2. ACTION ITEM: Recommendation to review and recommend approval to the City Council the Cedars Townhomes Preliminary Plat application, as conditioned, and adopt the Findings of Fact, Conclusions of Law, and Decision.

3. ACTION ITEM: Recommendation to review and approve the 450 Wood River Drive Residence Floodplain Development Permit application, as conditioned, and direct staff to return with the findings of fact.

**STAFF REPORT  
KETCHUM PLANNING & ZONING COMMISSION  
REGULAR MEETING OF MAY 28, 2024**

**STAFF REPORT**  
**KETCHUM PLANNING AND ZONING COMMISSION**  
**MAY 28, 2024 MEETING**

Sheet 1 of 1

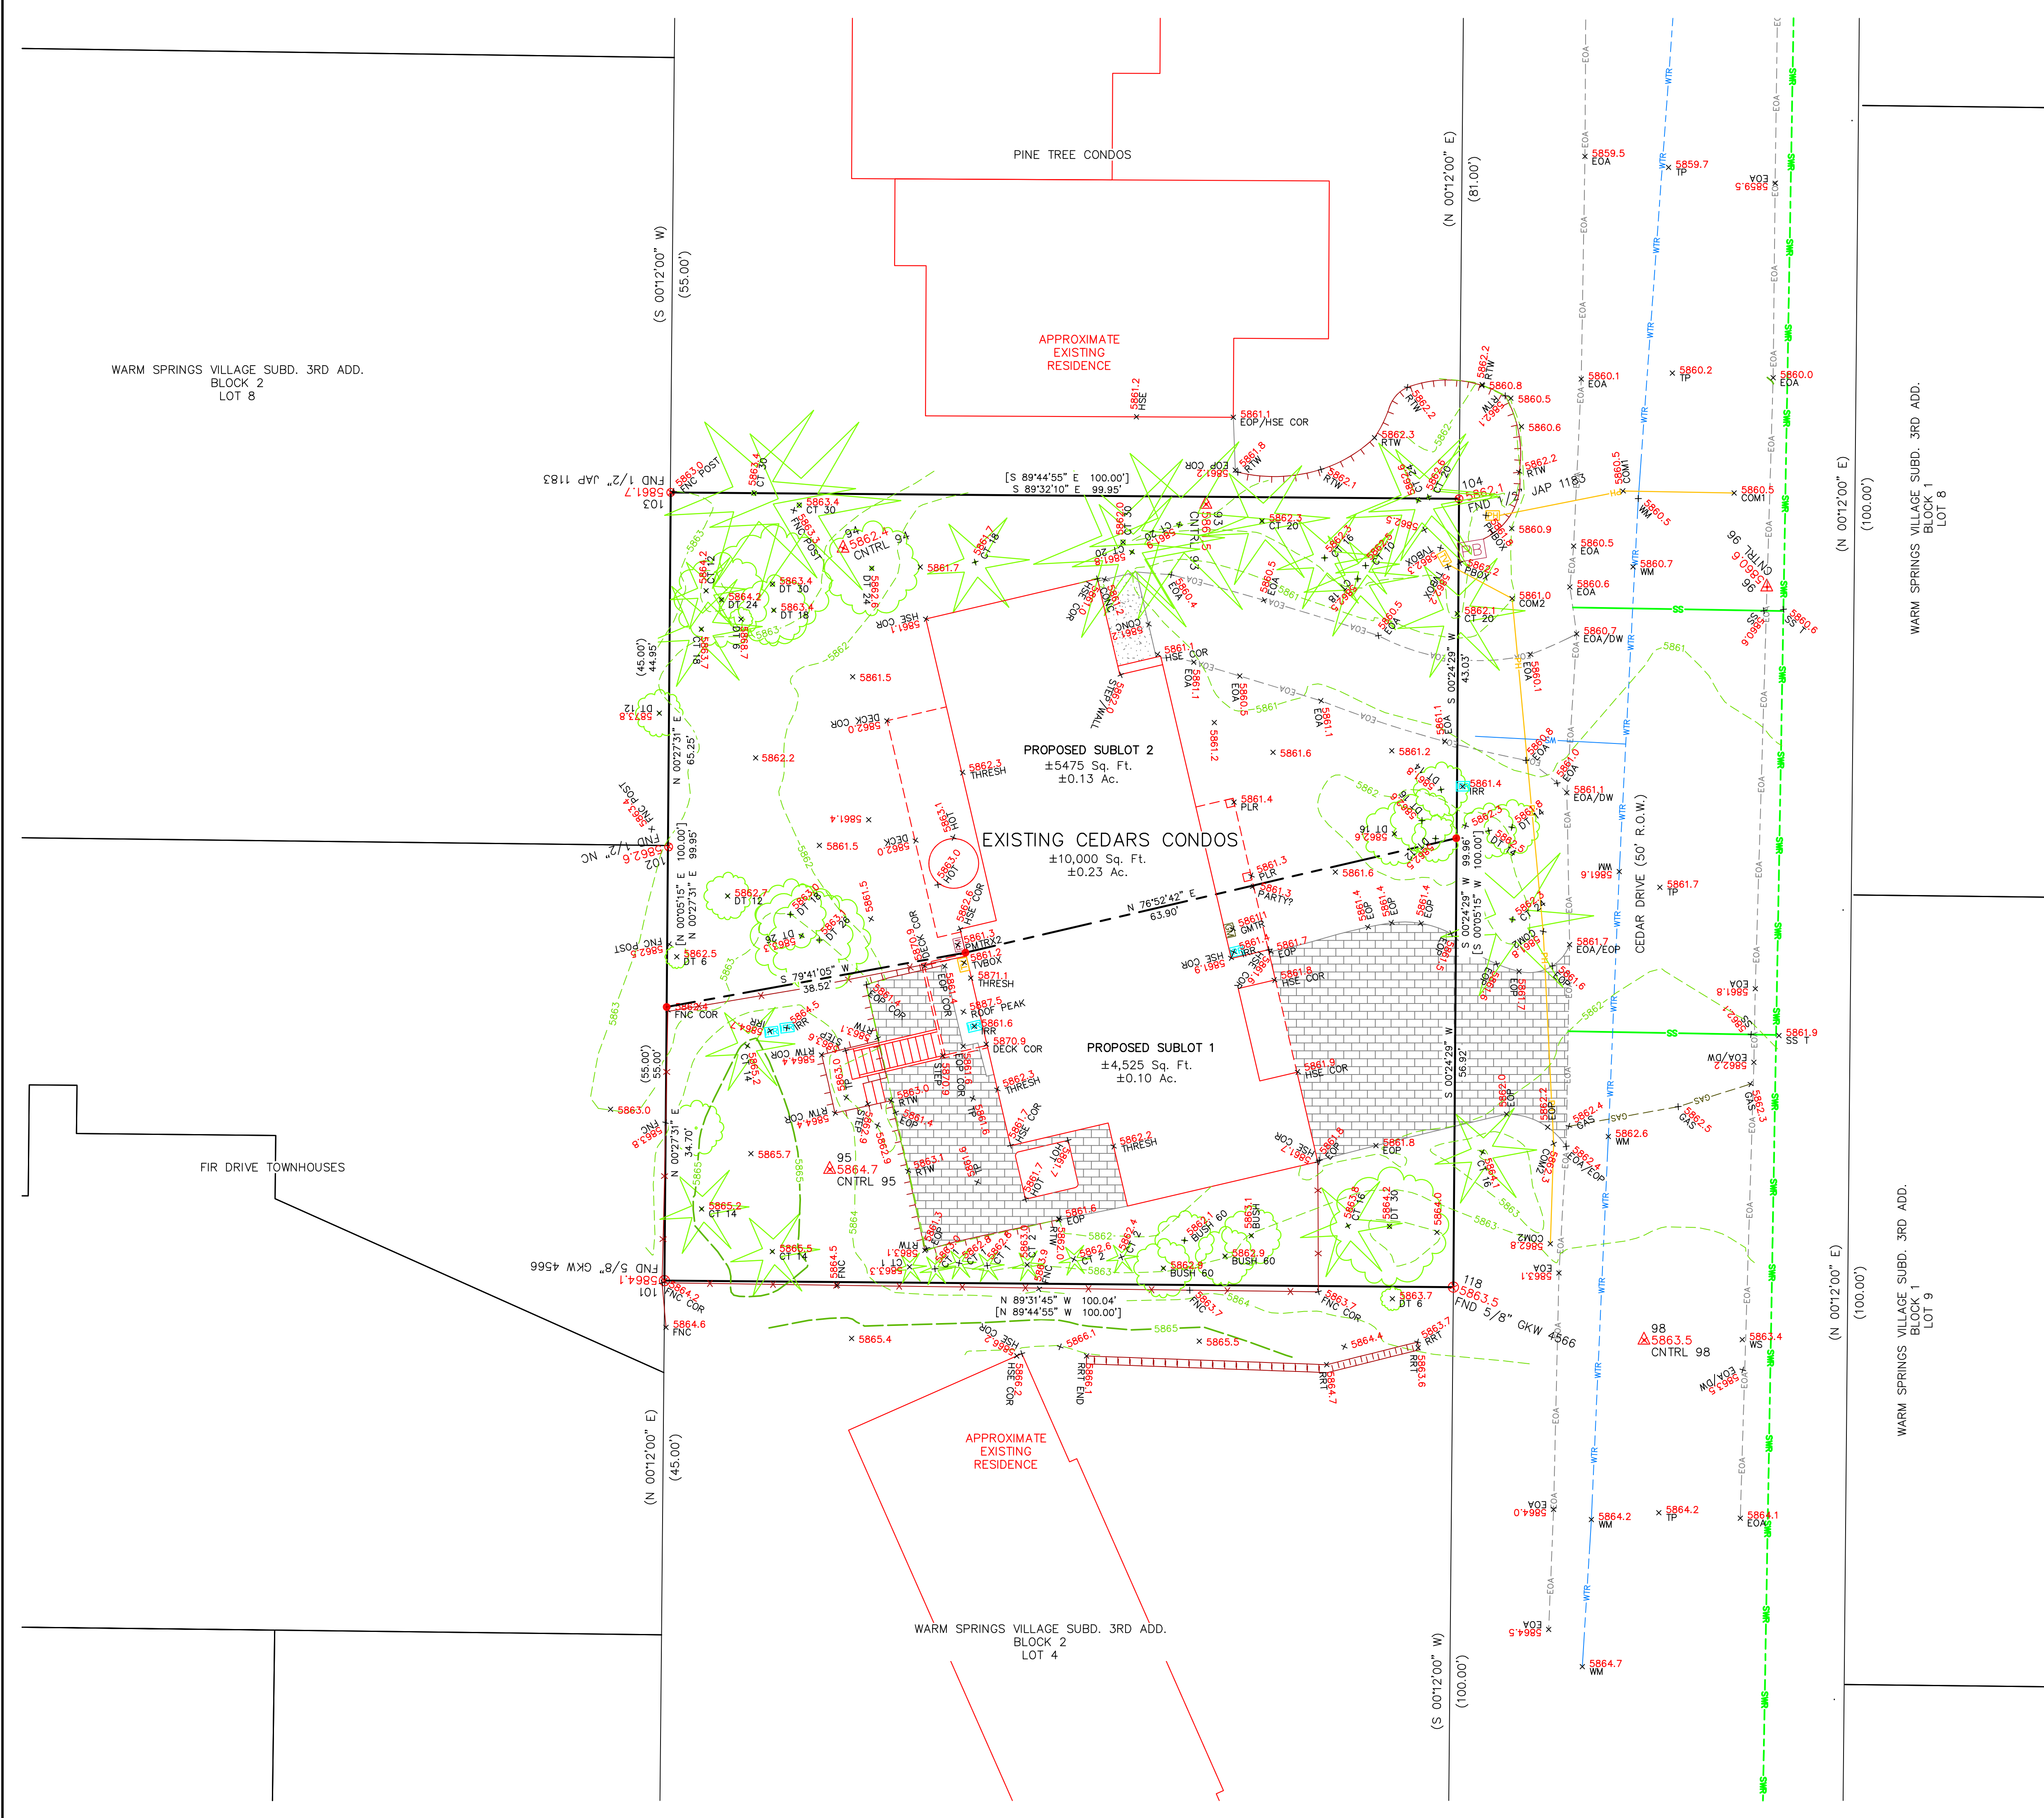
Pursuant to KMC 16.04.030.J.17, preliminary plats must include building envelopes on each lot within the A Zone. The Cedars Townhomes preliminary plat does not include building envelopes on the townhouse sublots. To ensure this standard is met, staff recommends condition of approval #2 which requires the applicant to revise the preliminary plat to indicate building envelopes on each townhouse subplot prior to City Council's review of the application.

water system main found on Cedar Drive to accommodate the transition to townhouse units. However, the preliminary plat indicates only one water service to subplot 2. Condition of approval #3 requires the applicant to revise the preliminary plat to indicate the location of the water service line for subplot 1.

1. Failure to record a Final Plat within two (2) years of Council’s approval of a Preliminary Plat shall cause the Preliminary Plat to be null and void.
2. Prior to City Council’s review of the preliminary plat application, the applicant shall revise the preliminary plat to include a building envelope on each townhouse subplot.
3. Prior to City Council’s review of the preliminary plat application, the applicant shall revise the preliminary plat to indicate the location of the water service line for subplot 1.

SHEET 1 OF 6  
**L-1.00**

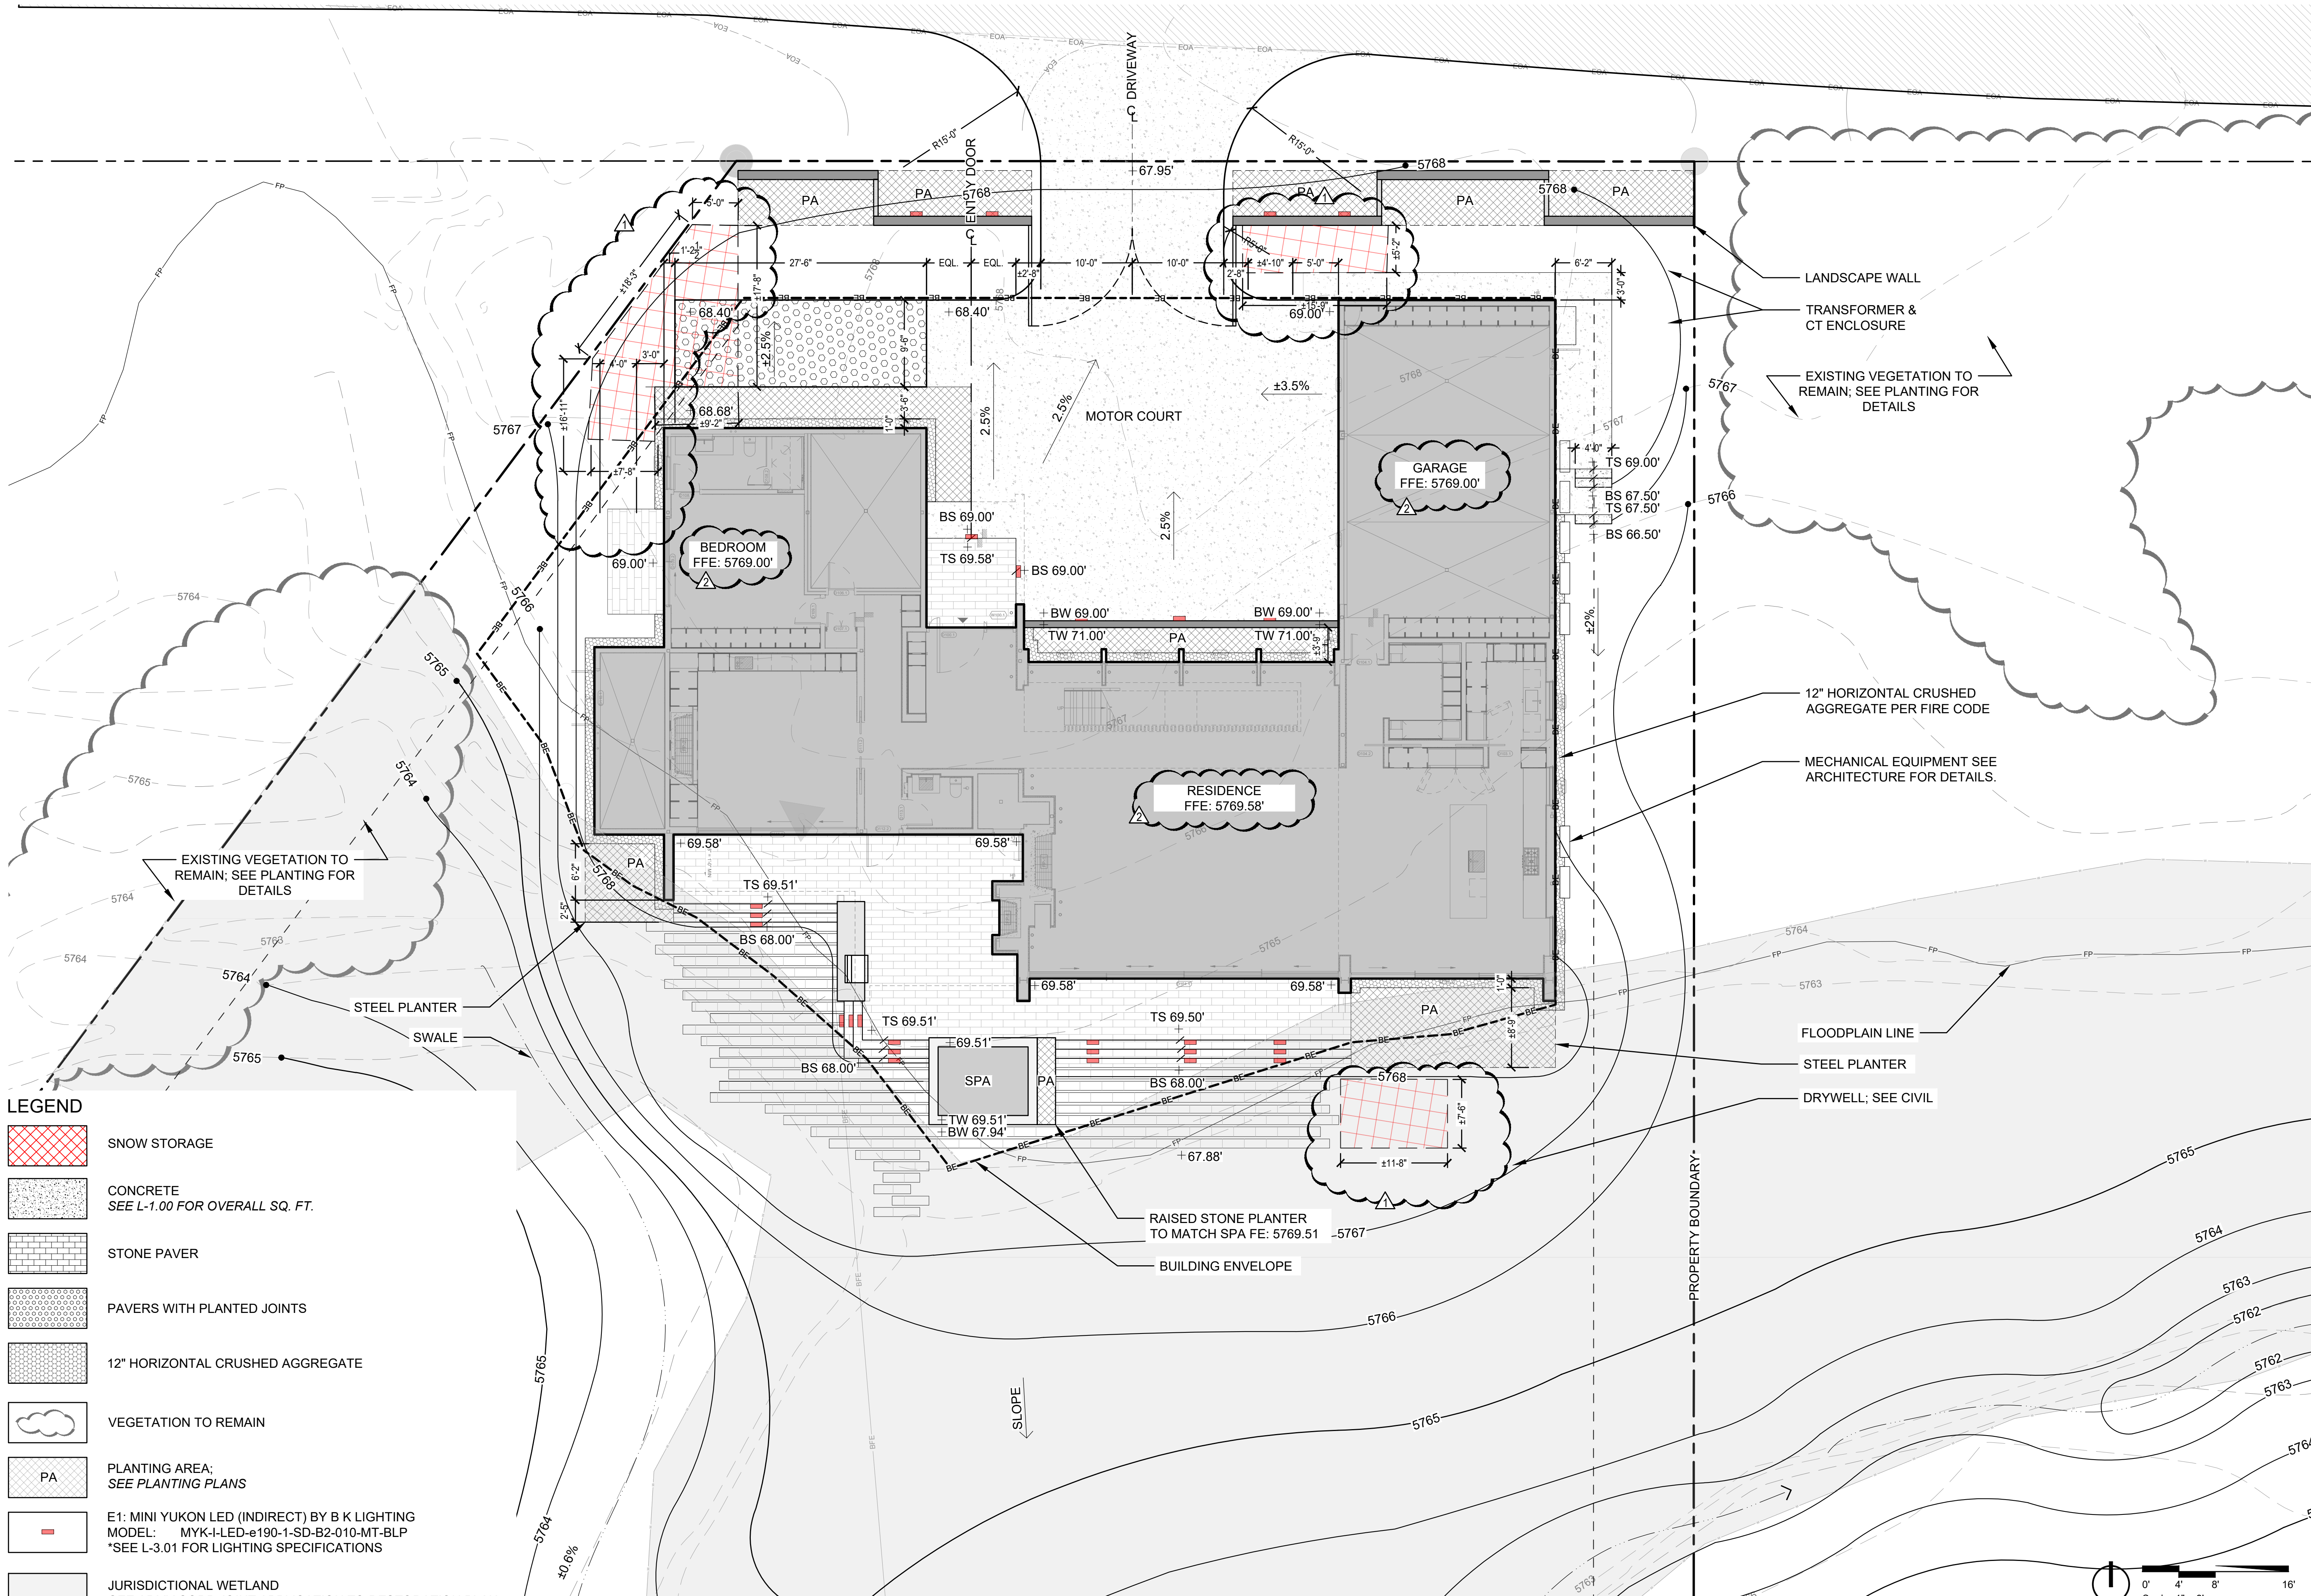
<p>Proposed:</p> <ol style="list-style-type: none"><li>1. As shown on Sheet L-1.00, 4,067 square feet of driveway and pedestrian circulation area is proposed. Of this total, 2,840 square feet is proposed to be snowmelted, leaving 1,226 square feet of non snowmelted area. The required amount of snow storage is 368 square feet and the applicant has proposed 400 square feet.</li><li>2. Proposed snow storage is located on subject property.</li><li>3. All snow storage areas do not dimensions less than 5 feet and have an area greater than 25 square feet</li><li>4. As stated in standard #1, snowmelt is proposed for 2,840 square feet of the proposed driveway &amp; pedestrian circulation area, resulting in 1,226 square feet of non snowmelted area.</li></ol>
--	--	--	--	--
